PIC16C64

PIC16C64 Rev. A Silicon Errata Sheet

The PIC16C64 (Rev. A) parts you have received conform functionally to the Device Data Sheet (DS30234D), except for the anomalies described below.

FIGURE 1: WRITES TO TIMER1 (EXTERNAL CLOCK / OSCILLATOR MODE)

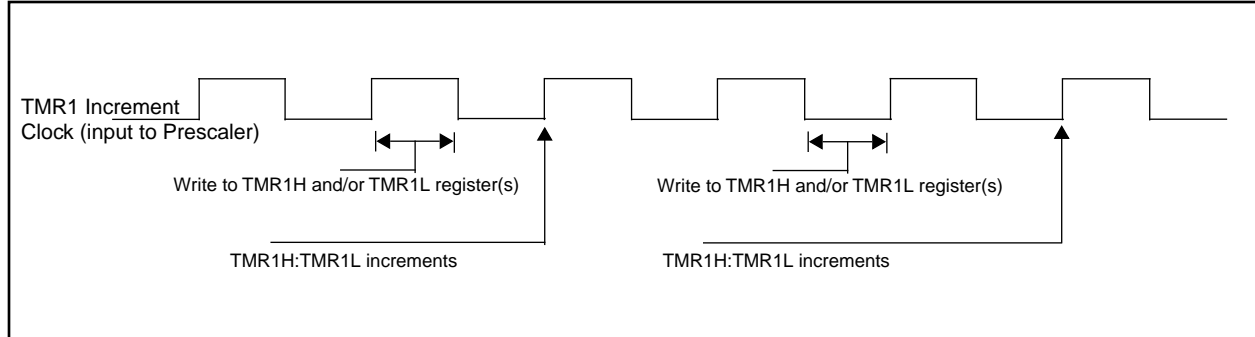
- a) The operation of Timer1 needs some clarification when the timer registers are written when the TMR1ON bit is set.
- The internal clock signal that is the input to the TMR1 prescaler affects the incrementing of Timer1 (TMR1H:TMR1L registers and the Timer1 prescaler). When the Timer1 registers are NOT written, the Timer1 will increment on the rising edge of the TMR1 increment clock.

When the TMR1H and/or TMR1L registers are written while this clock is high, TMR1 will increment on the next rising edge of this clock.

When the TMR1H and/or TMR1L registers are written while this clock is low, TMR1 will not increment on the next rising edge of this clock, but must first have a falling clock and then the rising clock for TMR1 to increment.

Figure 1 shows the two cases of writes to the TMR1H and/or TMR1L registers. Due to the V_{IH} and V_{IL} thresholds on the oscillator/clock pins, external

Timer1 oscillator components, and external clock frequency, the Timer1 increment clock may not be of a 50% duty cycle.

The TMR1 increment clock is out of phase of the T1OSO/T1CKI pin by a small propagation delay.
